Access Compliance Report

Public Rights-of-Way

(Pedestrian Signals)

Intersection ID: N/A	Main Street:	Cross Street: N/A	Location: N/A
ADA ID: 2E8E6BBA5C63	Signal Type: One Push Button-Non APS	Overall Compliance: No	Severity Score: BTN 1: N/A BTN 2: N/A No BTN: N/A
Codes/Mitigation Info/Possible Solution		Field Measurements/Component Compliance

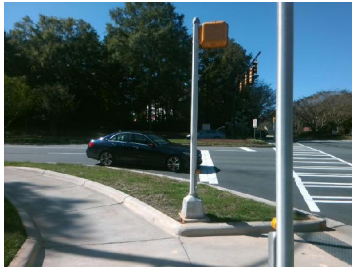
PROW/ADA: , TMUTCD 4e.08, R404.2, R404.7.3

Yes	B 1 Clear Xing Direction?	ClearlyMarked	N/A	B 2 Clear Xing Direction?	N/A
	B 1 Crossing Direction	To W		B 2 Crossing Direction	N/A
No	B 1 DistanceTo XWalk (in)	86.0	N/A	B 2 DistanceTo XWalk (in)	N/A
No	B 1 DistanceTo Curb (in)	96.0	N/A	B 2 DistanceTo Curb (in)	N/A
Yes	B 1 Diameter (in)	2.0	N/A	B 2 Diameter (in)	N/A

Possible Solutions: Replace Signal Push Button With APS Button on New Post. Remove & Relocate Sign.
